Access Compliance Report

Public Rights-of-Way

(Curb Ramps)

Intersection ID: N/A	Main Street: BRECKFIELD_CT	Cross Street: SHETLAND_LN	Location: NW
ADA ID: A4583BE3FCE9	Ramp Type: PerpDiag	Initial Pass/Fail: Fail	Overall Compliance: No
			Severity Score: 21.25

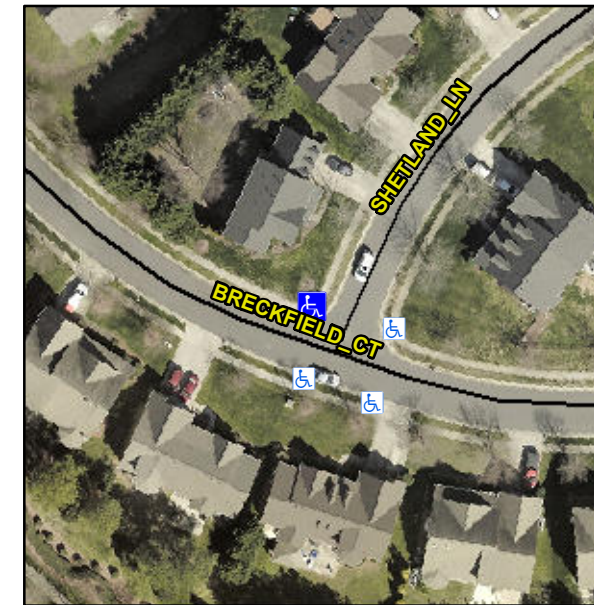
R304.5.1, R304.2.2

Compliance	Description	Data	Compliance	Description	Data
N/A	Ramp Length (in)	49.0	No	Ramp Slope (%)	10.8
No	Ramp Width (in)	45.5	Yes	Ramp XSlope (%)	1.3
N/A	Flare Type LT	N/A	N/A	Flare Type RT	N/A
N/A	Flare Slope LT (%)	N/A	N/A	Flare Slope RT (%)	N/A
N/A	Flare Traversable LT?	N/A	N/A	Flare Traversable RT?	N/A
N/A	Landing Length (in)	N/A	N/A	DWS Provided?	N/A
N/A	Landing Width (in)	N/A	N/A	DWS Contrast?	N/A
N/A	Landing Slope (%)	N/A	N/A	DWS Length (in)	N/A
N/A	Landing X Slope (%)	N/A	N/A	DWS Full Width?	N/A
N/A	Landing Curb? (Y/N)	N/A	N/A	DWS Offset (in)	N/A
N/A	Shared Landing?	N/A			
N/A	Gutter Ponding?	N/A	N/A	Gutter Slope (%)	N/A
N/A	Gutter Lip Ht (in)	N/A	N/A	Gutter X Slope (%)	N/A
N/A	Painted X Walk1?	No	N/A	Painted X Walk2?	No
	X Walk 1 Direction	To SW		X Walk 2 Direction	To SE
N/A	X Walk 1 Width (in)	N/A	N/A	X Walk 2 Width (in)	N/A
	X Walk 1 Slope (%)	1.4		X Walk 2 Slope (%)	2.1
	X Walk 1 X Slope (%)	2.2		X Walk 2 X Slope (%)	0.4

Remove & Replace Curb Ramp With Two New Directional Ramps or Equivalent.
